## Process Sheet

Customer : CU-DAR001 Dart Helicopters Services Drawing Name : 350 SKIDTUBE ASSEMBLY RH  
 Job Number : 39764  
 Estimate Number : 10265  
 P.O. Number :  
 This Issue : 10/06/2008 S.O. No. : Part Number : D350636012  
 Prsht Rev. : NC Drawing Number : D2750 UNDER REVIEW *At 08-06-11 per DSI 9413*  
 First Issue : 10/06/2008 Type : SKIDTUBES Project Number : N/A  
 Previous Run : 39763 Drawing Revision : E  
 Material :  
 Due Date : 30/06/2008 Qty: 1 Um: Each

# DART SERVICE INSTRUCTION

TO AMEND INSTALLATION INSTRUCTIONS IIN-D350-636 REV E

**FIGURE 1 - WEARPLATE MODIFICATION**

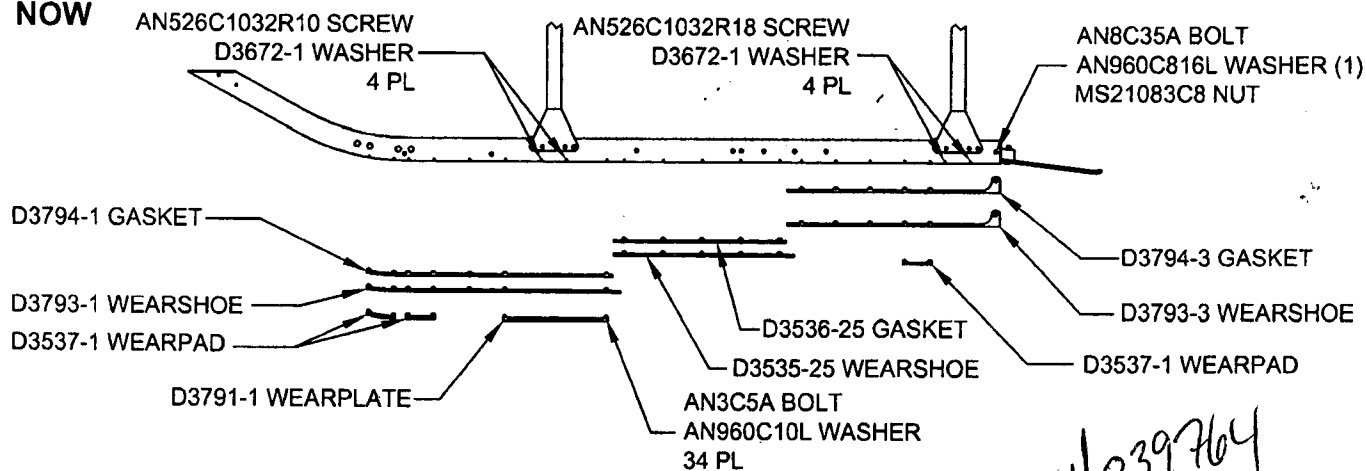
THE WEARPLATES ON D350-636-011/-012/-013/-014 SKIDTUBES AT CHG 004 (AND LATER) HAVE BEEN MODIFIED AS SHOWN IN FIGURE 1 BELOW TO ELIMINATE THE POSSIBILITY OF INTERFERENCE BETWEEN THE WEARPLATES AND CROSSTUBE SADDLES AT INSTALLATION. THERE IS NEGLIGIBLE WEIGHT CHANGE ASSOCIATED WITH THIS MODIFICATION.

(AN526C1032RXX SCREW LOCATIONS NO LONGER USED TO MOUNT WEARSHOES)

TO INSTALL THE DSI 9413-011 KIT, REMOVE THE EXISTING WEARSHOES/GASKETS UNDER THE FWD/AFT SADDLES AND INSTALL NEW WEARSHOES/GASKETS AS SHOWN IN FIGURE 1. PLUG UNUSED HOLES WITH AN526C1032RXX SCREWS AND D3672-1 WASHERS. INSTALL SCREWS WITH SIKAFLEX -241/-291 OR PROSEAL 890 OR MIL-S-8802 CLASS 'B2' SEALANT AS SHOWN IN FIGURE 1. **NOTE:** SOME OF THE PREVIOUSLY INSTALLED HARDWARE IS NO LONGER REQUIRED.
